Re: FortisBC Energy Inc. (FEI)

Project No. 1599211

Application for a Certificate of Public Convenience and Necessity (CPCN) for Approval of the Advanced Metering Infrastructure (AMI) Project (Application)

Response to the B.C. Sustainable Energy Association (BCSEA) Information Request (IR) No. 2

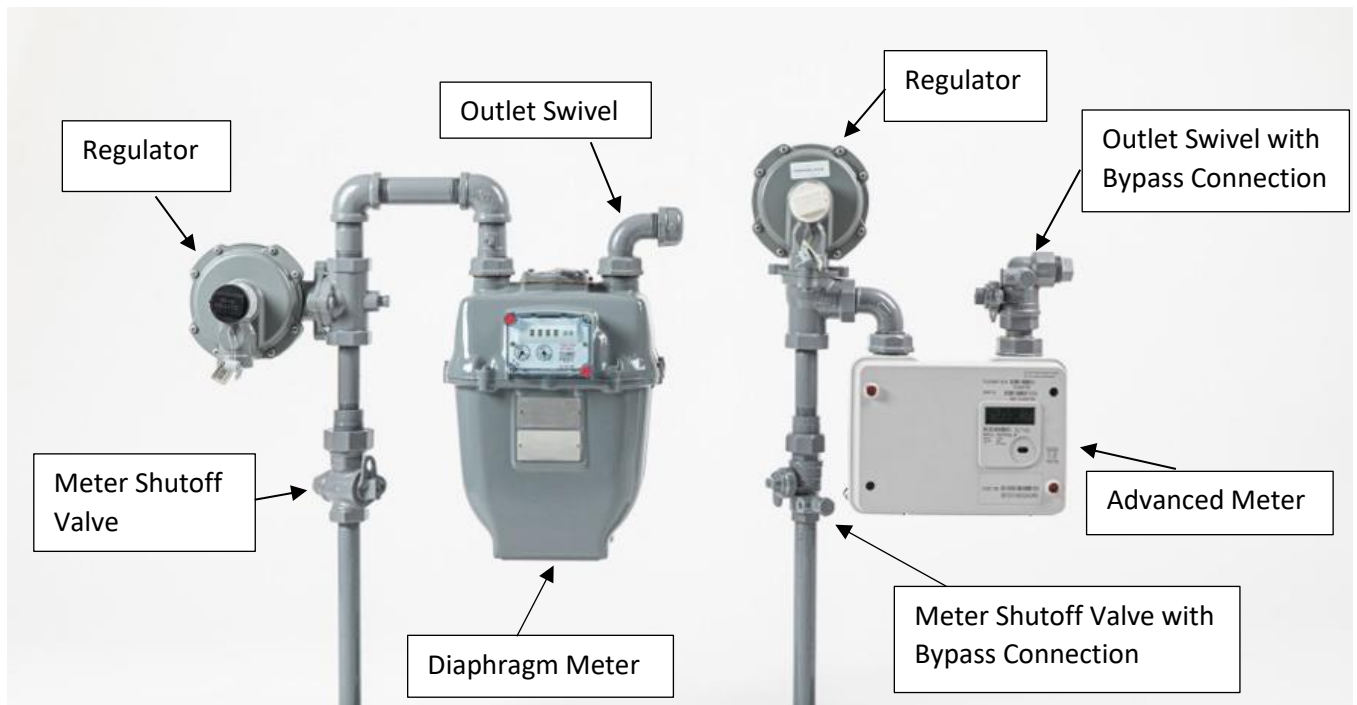
3 39.1 Please explain what a “meter set” includes in typical residential setting before and
 4 after the AMI Project. After the AMI Project, will a typical residential meter set
 5 include a meter, a bypass valve set and a regulator? Please provide images of a
 6 typical residential meter set (with and without a bypass valve set) before and after
 7 the AMI Project.

10 Currently, FEI’s residential and small commercial meter sets consist of a meter shut-off valve, a
 11 regulator, meter connections (inlet and outlet connections typically referred to as swivels), a
 12 meter, and miscellaneous fittings. After the AMI Project, FEI’s residential and small commercial
 13 meter sets will consist of these same items. The only difference is that, after the AMI Project,
 14 these meter sets will contain an advanced meter and bypass connection points on the meter
 15 shutoff valve and the meter outlet swivel.

16 Please refer to the image below which shows examples of both current and proposed meter sets.
 17 On the left is a typical meter set currently installed at residential and small commercial customer
 18 premises. On the right is a typical meter set that would be in use after the AMI Project is
 19 completed.
